MONTICELLO NUCLEAR GENERATING PLANT
Docket No. 50-263 License No. DPR-22

Supplementary Information Regarding the First Monticello Reload

CYCLE 2 CORE MONTICELLO

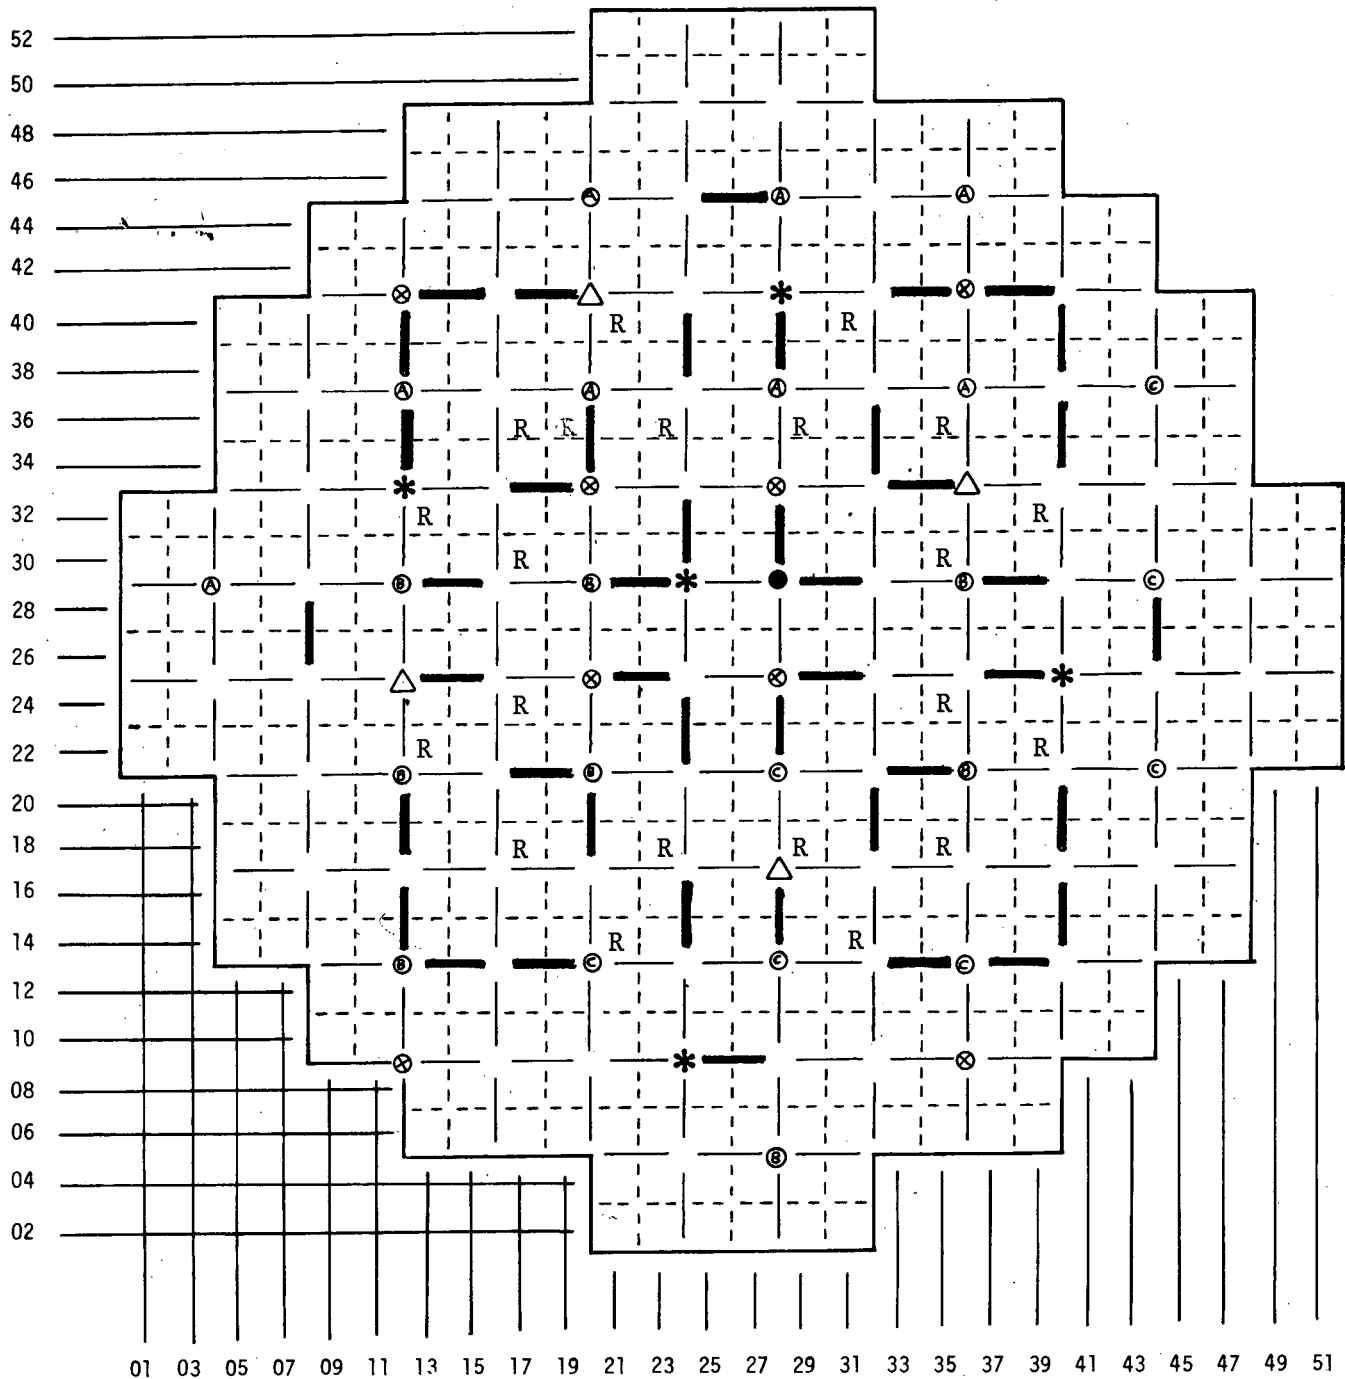
On February 20, 1973 we submitted a document entitled "First Reload License Submittal." Calculations performed in support of that document were based on a target exposure of 6800 MWD/STU. The plant capacity factor exceeded the estimate, resulting in an exposure of approximately 7100 MWD/STU at the date scheduled for the outage. We, therefore, intend to modify our previously reported plans somewhat to reflect the achieved cycle 1 exposure.

The reference core discussed in the initial submittal consisted of 28 R-1 type reload fuel assemblies with 456 initial core fuel assemblies having a preoutage average exposure of 6800 MWD/STU and 64 temporary control curtains. Allowable deviations of these parameters were also discussed to establish a window for the outage. Because exposure exceeded this window, a revised core loading plan has been selected which is compatible with existing exposure conditions. Our present plan is to load a cycle 2 core consisting of 20 R-1 type reload fuel assemblies with 464 initial core assemblies and 44 temporary control curtains. The shutdown margin for this core with the rod of highest worth fully withdrawn is calculated to be 0.015 delta k which is well in excess of the 0.01 delta k design requirement stated in the FSAR. The attached figure shows the planned cycle 2 core.

The safety analysis presented earlier has been reviewed, found to be unaffected by this change in core loading and found not to involve an unreviewed safety question. The Monticello Operations Committee and Safety Audit Committee have reviewed the revised loading plan.
